## Different technical modifications and updatings on coral 70s

Here below you will find the most important modifications carried out on above-mentioned machine. We ask you to carefully read all the information, necessary for your future orders. We add furthermore the summary and the updated index with all its revisions, so that you may check your files and ask for the missing tables.

Ref. table S0803-10 R00

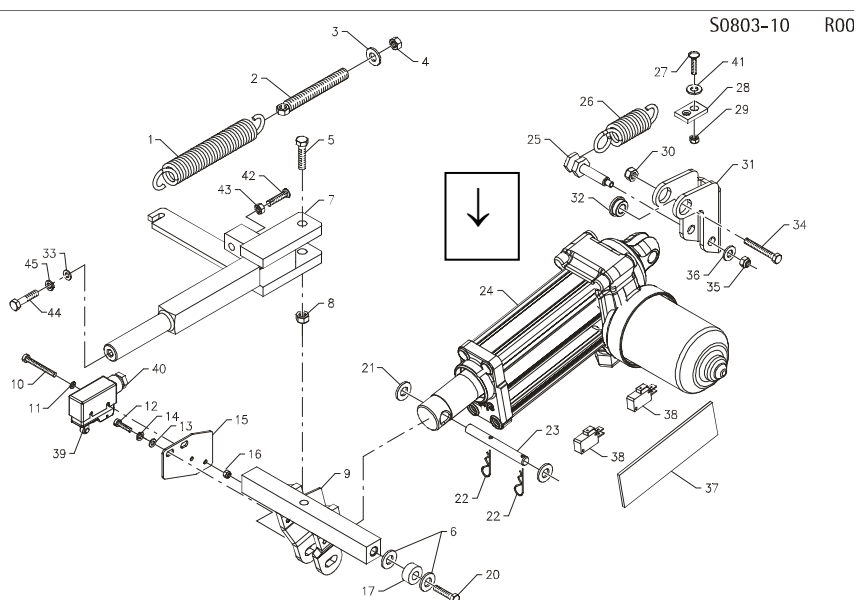
We have modified the drawing correcting mainly the design of the actuator.

→ Starting from serial number: 13003474 dated 11/10/13 – table S0801-10 R03

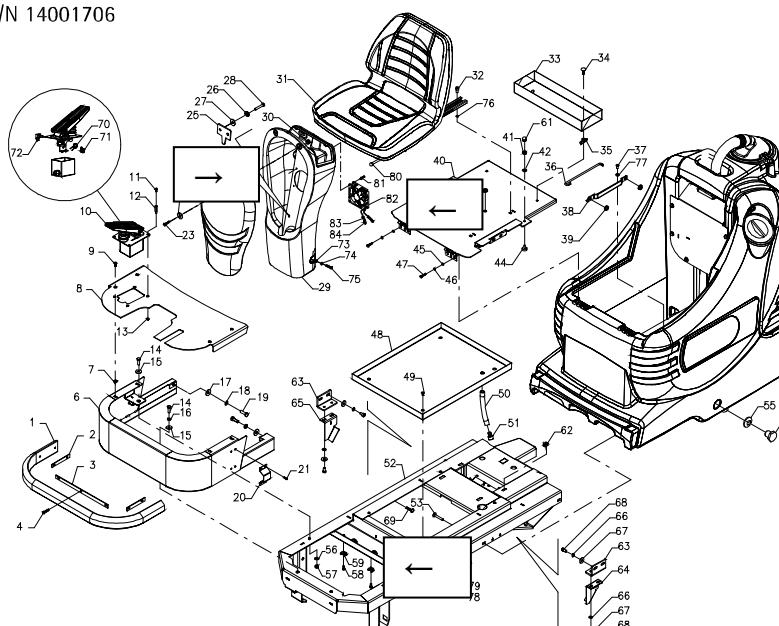
Actually the saddle supports (pos. 59) are assembled on the frame with a screw and nut. When the machine is assembled, it is difficult to reach the nut and a possible support replacement becomes onerous. To avoid this problem, the frame has been threaded directly. For this intervention the screw M5x14 has been replaced with a M5x8 one and the nut has been removed.

To avoid that with the vibrations the screws may get loose, put a drop of locking liquid, Loctite 641, onto the thread.

S0801-10 R04

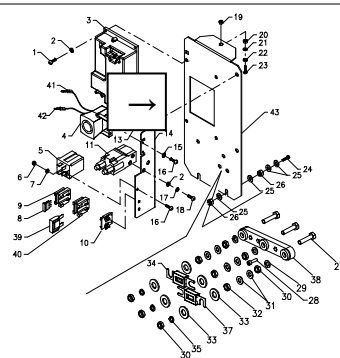
To improve the performances of the chopper card, we have added a cooling fan. This device requires the realization of ventilation openings on the front column, on the front frame and on the electric panel. The modification can be applied also on already produced machines. The complete assembly of the fan has part number: V0812010

The assembling instructions with No. T081208 are available.

Ref. table S0804-20 R01

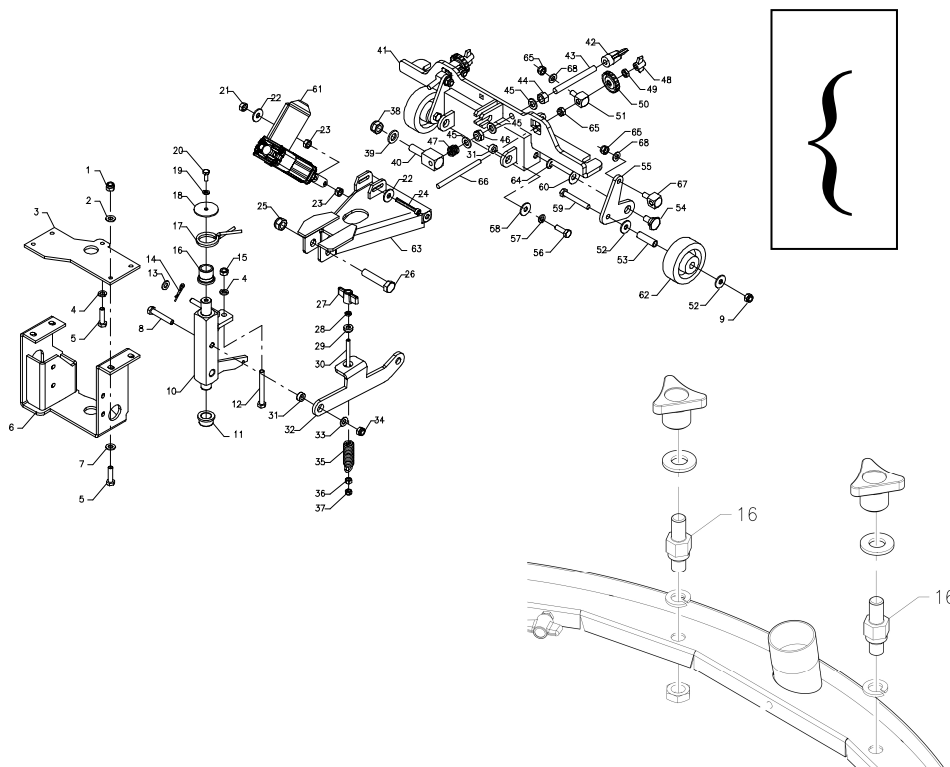
We have added in the description positions 28 and 29.

→ Starting from serial number: 14001435 – table S0809-10 R01

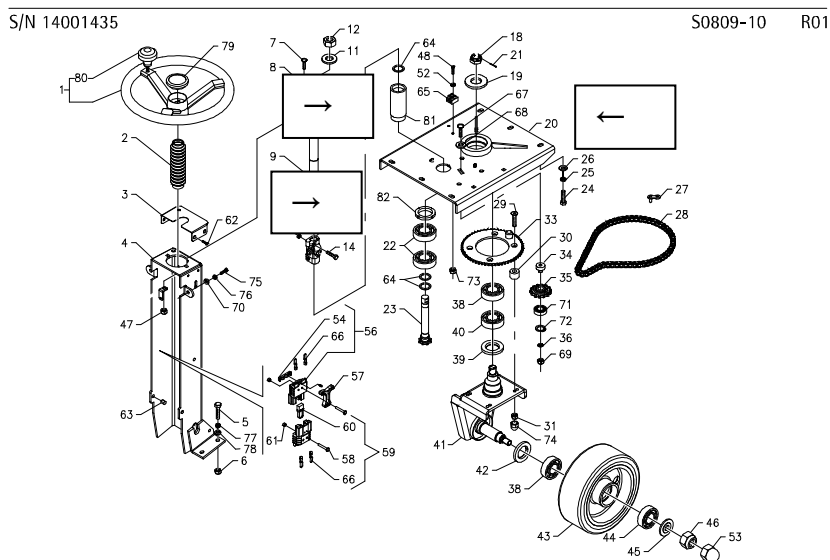
The bearing pipe of the steering wheel pinion becomes disassembled because welding it to the steering wheel support the seat of the lower bearing is often deformed. This application is already assembled on coral 65m. On the steering wheel support (pos. 20) the hole has been modified by increasing the diameter to 50,5mm and realizing an anti-rotation key. On the pipe (pos. 81) an M50 thread has been obtained with a grooved seat for the key. The fixing is obtained by screwing the ring nut M50 (pos. 82). In case of spare parts requests, we can supply in place of part number 20809040 (steering wheel support) the assembly made of:

- pos. 20 20809060 steering wheel support
- pos. 81 20809320 pipe bearings
- pos. 82 60285010 blocking ring nut M50x1,5

→ Starting from serial number: 14000479 dated 28/01/14 – table S0810-20 R03

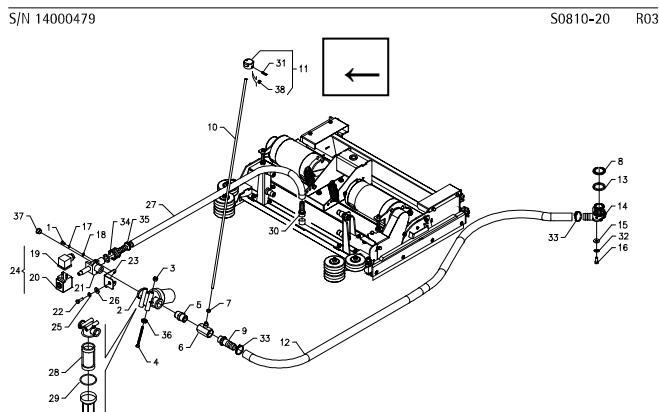
We have replaced the solution valve knob made with a mould designed in PA6 + glass fiber. The new part is interchangeable with the previous one.

→ Starting from serial number: 13003293 dated 02/10/13, table S0812-20 R04, pos. 5

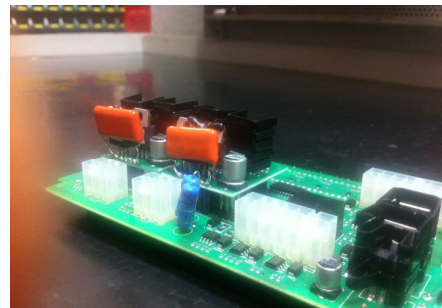
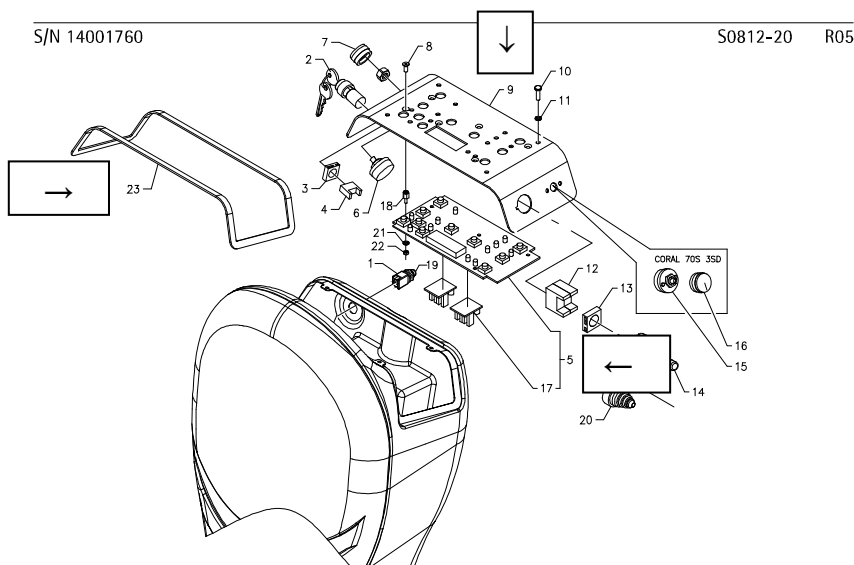
We have replaced the fuse 62801003 of 10A with one of 15A having part number 62801501. This fuse is assembled on the check card of the functions, pos. 5.

We enclose the modified electric diagram, Cre0812-20 R01 (pos. F5).

→ Starting from serial number: 14001760 dated 08/05/14, table S0812-20 R05 and table S0801-10 R05

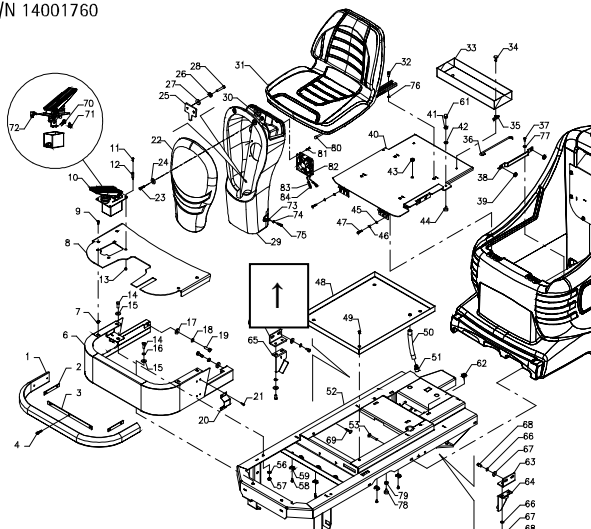
The front covering and the control panel has been replaced to fit the sealing gasket. The housing of the control panel (pos. 9) has been enlarged to permit the assembly of a sealing gasket (pos. 23). The modification requires an intervention on the mould of the front covering 20611010 which cannot be supplied anymore as a spare part for the produced machines. In case of spare parts requests, it is necessary to supply the new front covering with the new control panel and the gasket, informing us about the colour of the covering. The label of the control panel remains unchanged.
